UNITED STATES ENVIRONMENTAL PROTECTION AGENCY  
RESEARCH TRIANGLE PARK, NC 27711

SUBJECT: Model Clearinghouse Review of Use of Non-default Radius for Determining Surface Roughness Length for AERMET

**SUBJECT:** Kentucky NewGas Project – Site-Specific, Non-Default Radius for Roughness Determination

Figure 1. Surface Roughness Estimates by Sector for BWG Airport - AERSURFACE vs. GFM

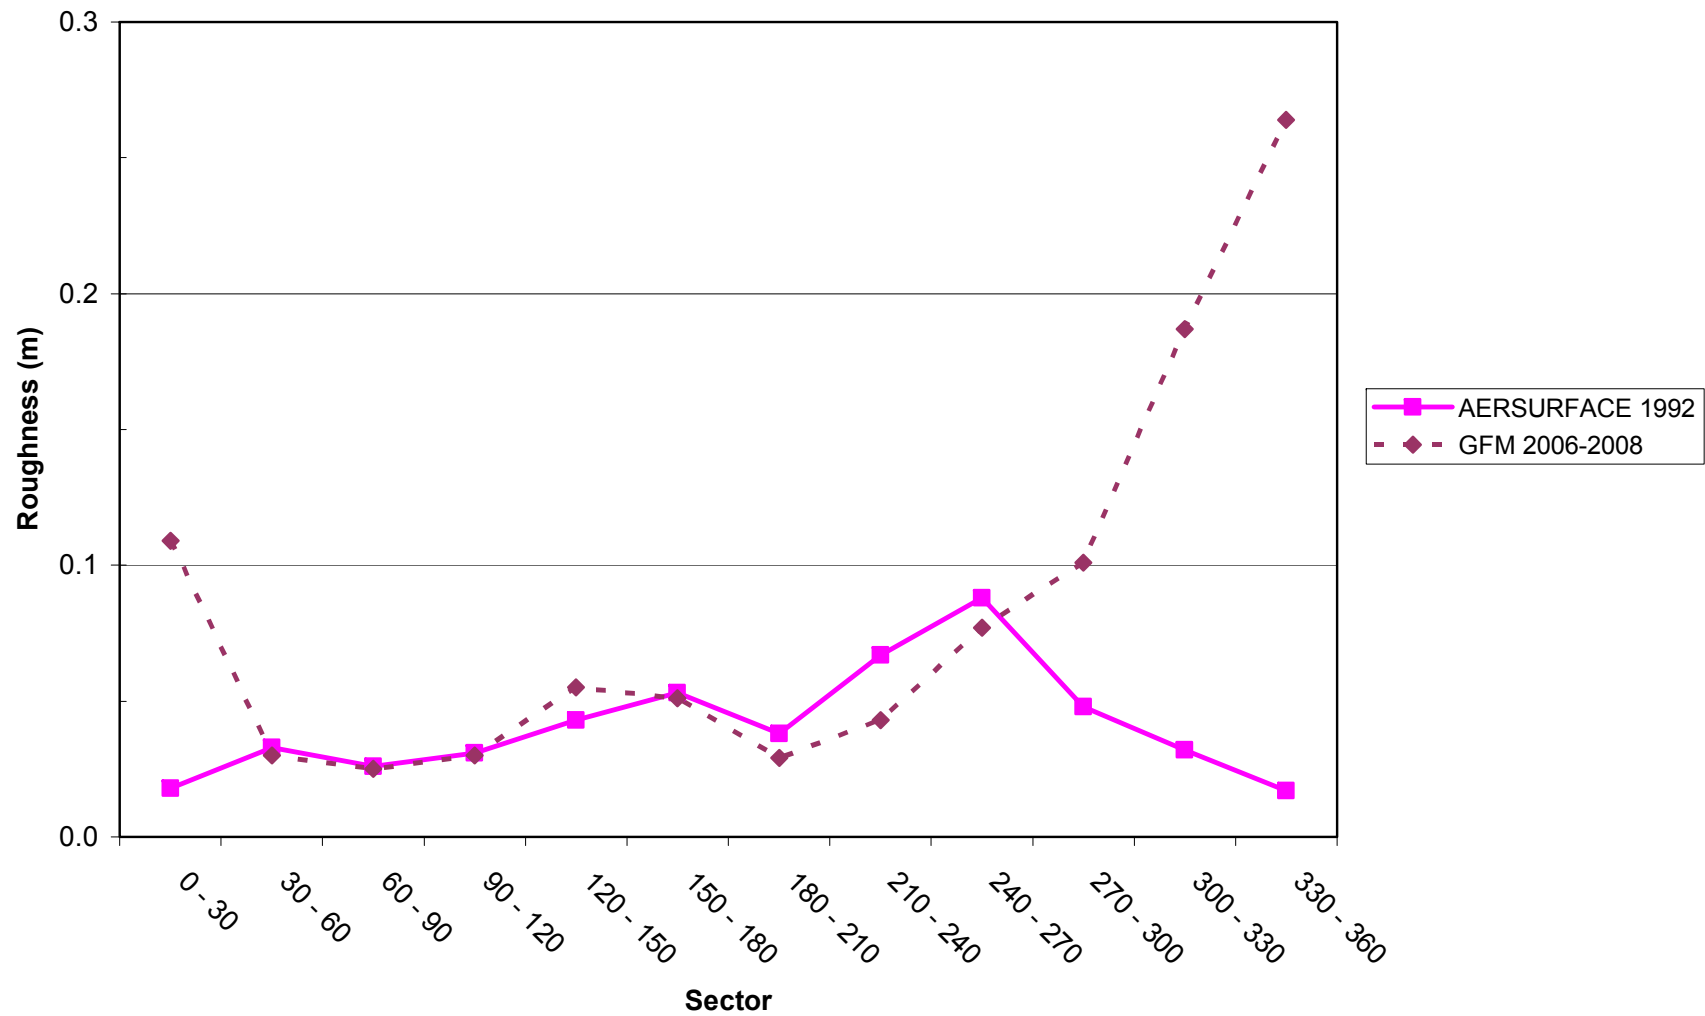
As part of our review of the Region 4 request, we have also applied the GFM to estimate surface roughness for the BWG site, using available 1-minute ASOS wind data for 2006 through 2008. The results of this test, presented in Figure 1, show generally good agreement between AERSURFACE estimates using the default 1 kilometer radius and GFM estimates across most sectors. The AERSURFACE roughness estimates are slightly higher than the GFM estimates for the 240°-270° sector highlighted in the Region 4 memorandum as showing a significant increase in roughness with increasing radius. However, significant differences between the AERSURFACE and GFM estimates are found for the WNW through N sectors, with higher roughness estimates based on the GFM than AERSURFACE. These differences appear to be attributable to a significant change in land cover for those sectors for the 2006-2008 period used in the GFM compared to the 1992 NLCD used in AERSURFACE. A review of the aerial photo provided with the Region 4 request taken in March 1993 shows indications of a golf course under construction in very close proximity to the meteorological tower (within about 50 meters). More recent aerial photos show the completed golf course surrounding a residential community and other commercial buildings. Figure 2 provides an aerial photo of the site from 2008. The proximity of this change in land cover to the meteorological tower contributes to the significantly higher roughness values for those sectors based on the GFM than estimated by AERSURFACE based on 1992 NLCD, which depicts the area as “Urban/Recreational Grasses”.

These comparisons of roughness estimates for BWG based on AERSURFACE and the GFM provide some objective support for the Model Clearinghouse response to the Region 4 request regarding use of a non-default radius for estimating surface roughness values for use in processing the BWG meteorological data. They also illustrate the importance of assessing the temporal representativeness of the land cover data for the meteorological data period being processed. In this case, use of AERSURFACE roughness estimates with recent meteorological data for BWG (later than about 2000) could significantly underestimate the surface roughness for the WNW through N sectors. We would recommend adjusting the surface roughness values estimated by AERSURFACE based on these GFM results for upwind sectors between about 270° and 30° when processing BWG data for recent years, while using AERSURFACE estimates based on the default 1 kilometer radius for other sectors.

**FIGURE D-5. LANDUSE AND LAND COVER SURROUNDING THE PROPOSED KENTUCKY NEWGAS FACILITY**

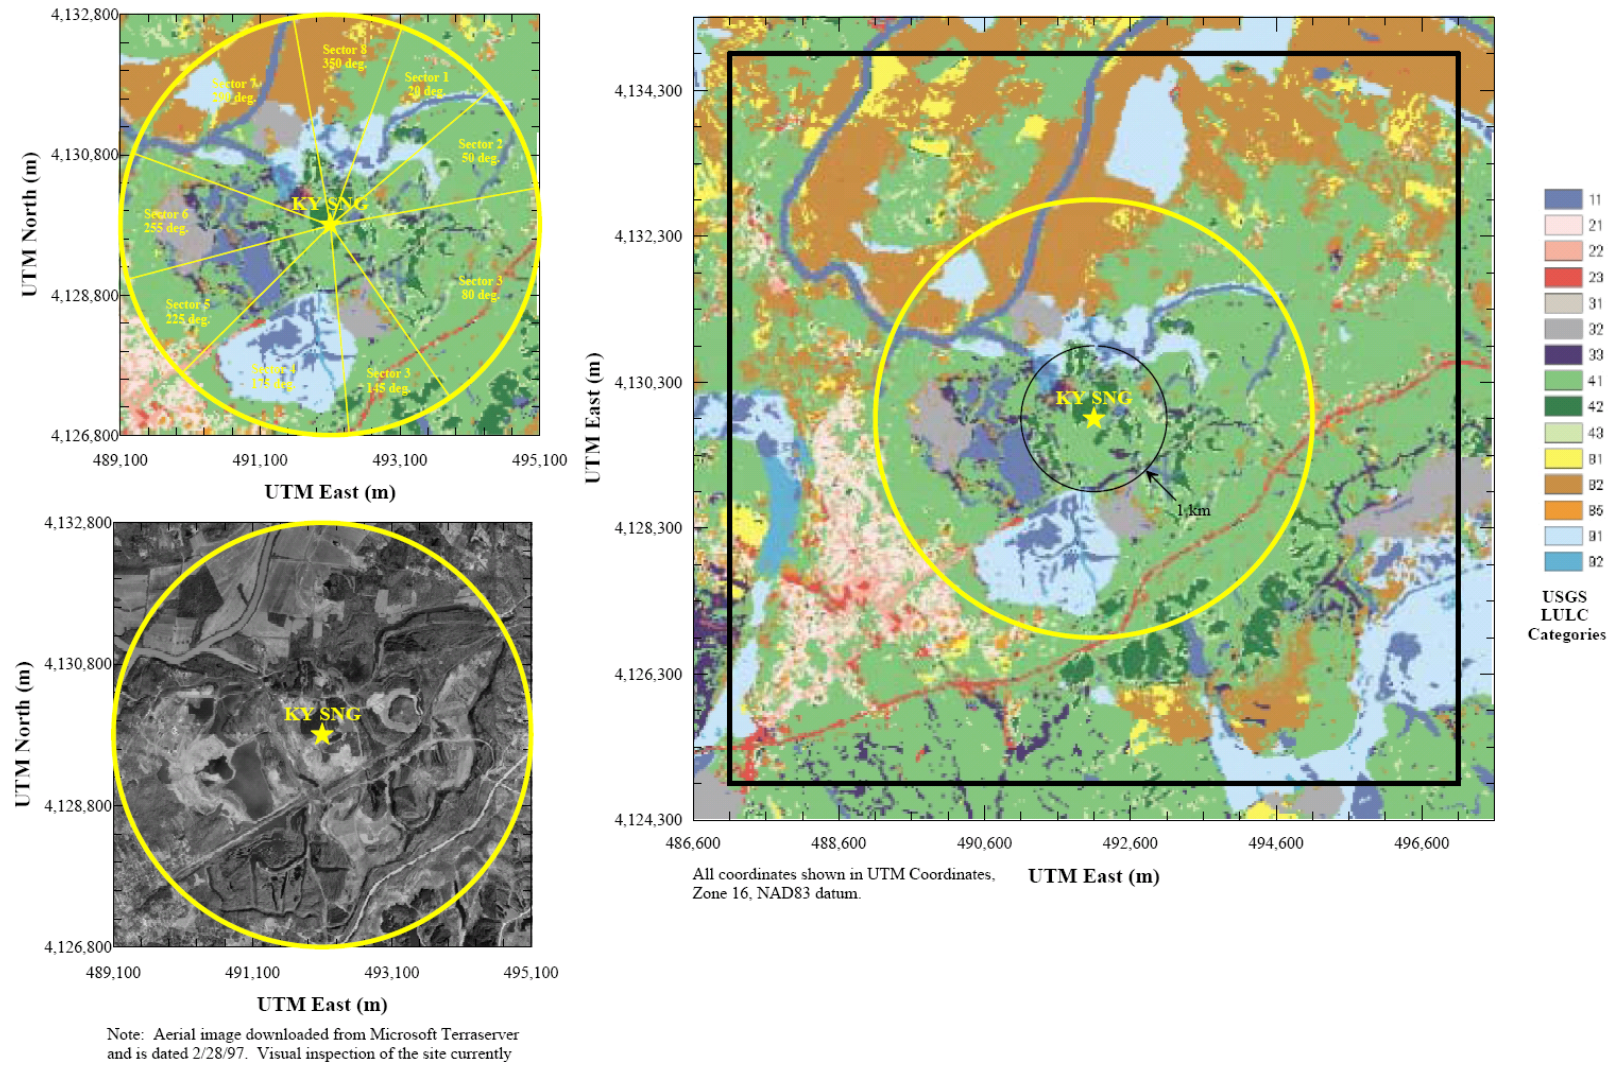
In a Prevention of Significant Deterioration (PSD) application for the proposed KYNG facility, they state that the land cover figures (Attachment 1 - Figure D-5, and Attachment 2 – Figure D-6) show significant discontinuities in the land use surrounding the Bowling Green NWS (BWG) site, the source of the meteorological measurements used in the air quality impact modeling, and the project location just beyond the 1 km recommended radius justifying the use of larger site-specific radii for these locations.

Review of the land cover for KYNG site in Figure D-5 reveals land cover changes just beyond 1 km (i.e., between 1.0 and 1.5 km). The changes occur in the northeast, southeast, southwest, and northwest directions from the proposed project location. The BWG site in Figure D-6 also reveals land cover changes just beyond the 1 km radius (i.e., between 1.0 and 1.5 km) to the west, northwest, and north of the tower. The expected

Given the lack of any technical rationale based on the physics of boundary layer modeling to justify use of a non-default radius for determining surface roughness, the Model Clearinghouse cannot support Region 4’s position on this application. While this response applies to the analysis for both the BWG and KYNG sites, the intended use of the surface roughness values at the proposed KYNG project site and their relevance to this analysis are not explained in the Region 4 request. Since the guidance clearly states that the surface roughness input to AERMET should reflect characteristics at the meteorological monitoring location, the Clearinghouse has no comment on the appropriate determination of surface roughness at the KYNG site.
